SERVICE BULLETIN

Transmittal of Revision 1 to Service Bulletin V2500-ENG-72-0178

V2500-ENG-72-0178

ENGINE - HP COMPRESSOR DISCS - STAGE-3 TO 8 ROTOR DRUM WITH THICKER STAGE-6 DISC HUB AND DAMPING WIRE LOCATION LIPS

Location of the Stage-3 to 8 HP Compressor disc assembly. Figure 1

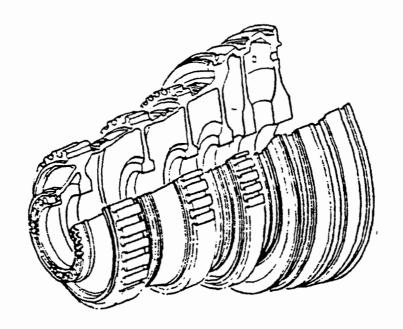
- (1) For the A5 and D5 engines, this Service Bulletin introduces a new Stage-3 to 8 drum assembly with the changes that follow:
 - (a) The nominal width of the Stage-6 disc hub has increased.

- (b) The diameter of the blade support lips for the Stage-6, 7 and 8 discs has been reduced. This is to maintain the original values of the under-platform clearances.

- (c) The width of the damping wire location lips of the Stage-7 and 8 discs has increased.
 - (d) For the effect on declared lives, refer to the applicable Engine Manual (EM), Chapter/Section 05-10-01, Group-A part lives.

- (2) For A1 engines, this Service Bulletin introduces a new Stage-3 to 8 drum assembly with the changes that follow:
 - (a) The diameter of the blade support lips for the Stage-6, 7 and 8 discs has been reduced. This is to maintain the original values of the under-platform clearances.

- (b) The width of the damping wire location lips of the Stage-7 and 8 discs has increased.
 - (c) The scroll on the abrasive coating between the Stage-6 and 7 discs and the Stage-7 and 8 discs are deleted.

- (d) The configuration of the blade locking slots on the Stage-6 and 8 discs has changed.
 - (e) The thickness of the Stage-7 disc diaphragm has decreased and the thickness of the Stage-8 disc has increased.

A1 MODEL REMOVE 6A5594 6A5592 6A5659 INSTALL 6A5467 REMOVE 6A4900 INSTALL 6A5467
